NL-04-0992

Vogtle Electric Generating Plant  
Response to Request for Additional Information Regarding  
Request to Revise Technical Specifications and  
Pressure and Temperature Limits Report

**Vogtle Electric Generating Plant  
Response to Request for Additional Information Regarding  
Request to Revise Technical Specifications and  
Pressure and Temperature Limits Report**

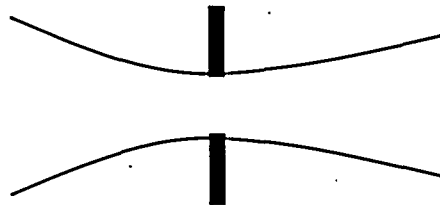
**Please Identify the calculations you performed that justify lowering the minimum Reactor Coolant System vent size from 2.4 inch<sup>2</sup> to 1.5 inch<sup>2</sup>.**

The first method performed an orifice calculation to obtain the minimum vent area. Using this method, it was assumed that the orifice is installed within the pipe (as shown below) and there is some pressure recovery across the opening.

Enclosure 4 contains a summary of the calculations which justify lowering the Reactor Coolant System vent size.

Method	RCS vent size required to relieve 685 gpm at 722 psig
1	.9827 in <sup>2</sup>
2	1.1178in <sup>2</sup>
3	1.284 in <sup>2</sup>

A vent size of 1.5 in<sup>2</sup> will bound all 3 methods considered and ensure the required relief capacities can be obtained.

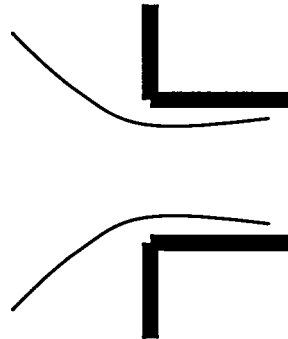
The other two methods assume that there is no pressure recovery and that the expansion takes place to the atmosphere. Method two performs an orifice calculation to determine the orifice diameter. This method assumes that the fluid is contained in an infinite vessel and is released to the atmosphere through the orifice, as shown below.
